GENERAL MOTORS 4L60E/4L65E/4L70E

Several changes have occurred on the 700R4/4L60E family of transmissions since 1982. One of the more recent design changes, which started to be phased into early 2006 models, has resulted in another model name, 4L70E.

Pump Cover/Shaft

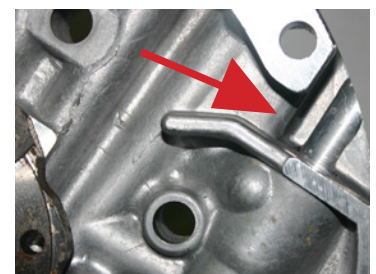
Changes in the pump cover were phased in beginning in early 2006, and specific model applications will dictate which design is required. The key here is having the right combination. There are three main areas of concern:

1. Is the hole drilled for the ISS or not?
2. Does the stator support sleeve have the large sensor hole?
3. Does the cover require the long or short boost valve/sleeve?

The newest cover casting #24230672 has a cut-out for the harness plug, and requires the short boost valve/sleeve.

The cover may or may not be drilled for the ISS or have the large hole stator sleeve. If the cover is drilled for the ISS and has the large sensor hole in the sleeve, it must be matched to a reluctor type input shaft due to the ring grooves/stator sleeve holes being repositioned (regardless of the reluctor grooves being cut).

ISS Harness Pathway

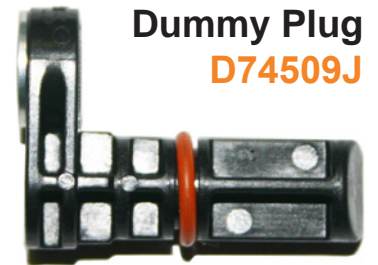
1. Fill in the ISS hole with either the sensor **D74438G** or dummy plug/
O-ring **D74509J** depending on requirements.
2. Use the proper input shaft/stator sleeve match as well as the correct
length of input/stator (298mm short/300mm long).
3. Ensure the correct boost valve/sleeve is used, based upon the bore
depth of the cover or oil hole position, or PR spring compression
will be affected.

NOTE: Earlier interim covers I.E. (24206611, HX024075) have
different arrangements as well.
